ADDRESSEES	: Owners and operators of coaches listed under “Application” ABC Customer Care and Parts Source
VEHICLE MODEL	: CX45 MY 2023
MANUAL SECTION	: 8.14 Climate control – refrigerant system
BULLETIN TYPE	: Field change campaign
DATE	: April 24 th , 2023
SUBJECT	: Incorrect position of high-pressure switch and test connection on refrigerant compressor discharge service valve
TERMS & CONDITIONS	: Refer to the warranty section further in this Bulletin.

Model	VIN
CX45 MY2023	81819→81820, 81976 , 84001→84050

Figure 1: Incorrect position of high-pressure switch and test connection on refrigerant compressor discharge service valve

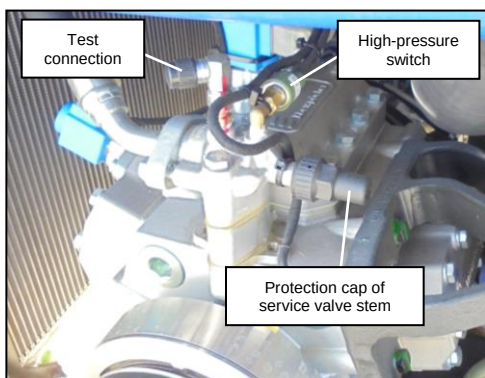
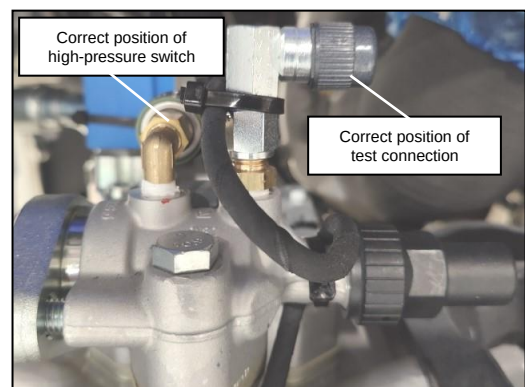
- Van Hool has determined that the position of the high-pressure switch and the test connection on the refrigerant compressor discharge service valve has been incorrectly placed during the assembly process. The result is that the high-pressure protection system of the refrigerant circuit is not working when the discharge valve is in its normal running position (refer to figure 3 for service valve positions).
- To address this issue, Van Hool is conducting a field change program, the terms and conditions of which are explained further on under “Warranty”.
- Owners and operators of the affected units should first check the position of the high-pressure switch and, if necessary, modify the placement.

Figure 2: Correct position of high-pressure switch and test connection on refrigerant compressor discharge service valve

Step	Action
3.1	Screw the fitting adapter holding the test connection assembly out of the refrigerant compressor.
3.2	Screw the elbow fitting holding the high-pressure switch assembly out of the refrigerant compressor.
3.3	Apply sealant tape VH11640236 or similar to the threads of the elbow fitting holding the high-pressure switch assembly. Screw the elbow fitting into the tapped hole located furthest away from the protection cap of the valve stem.
3.4	Apply sealant tape VH11640236 or similar to the threads of the fitting adapter holding the test connection assembly. Screw the fitting adapter into the tapped hole located the closest to the protection cap of the valve stem.

Figure 3: Service valve positions

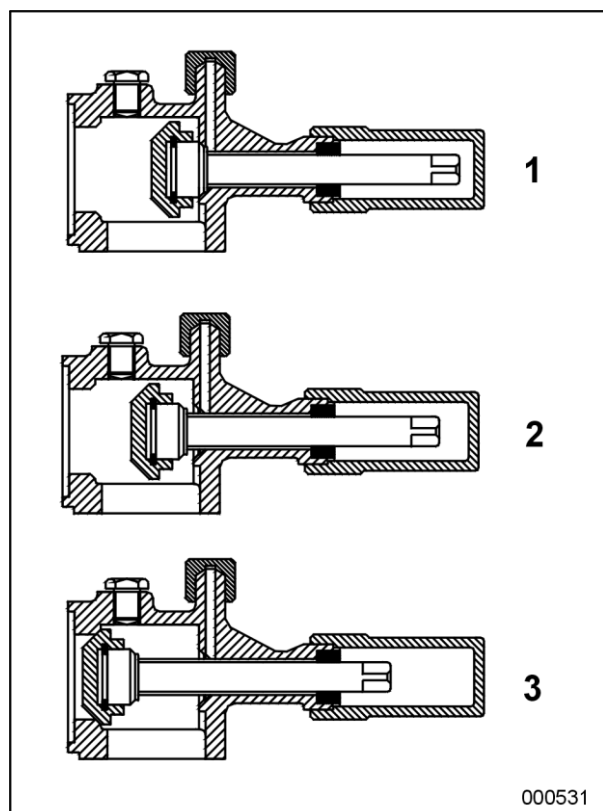
Number in figure 3	Position	Result
1	Valve stem rotated anti-clockwise as far as possible. This is the normal running position.	The valve is open, but the service port is isolated from the refrigerant circuit.
2	Valve stem in the mid-position. This is the test position.	The valve is open, and the service port to the refrigerant circuit is open.
3	Valve stem rotated clockwise as far as possible.	The valve is closed.
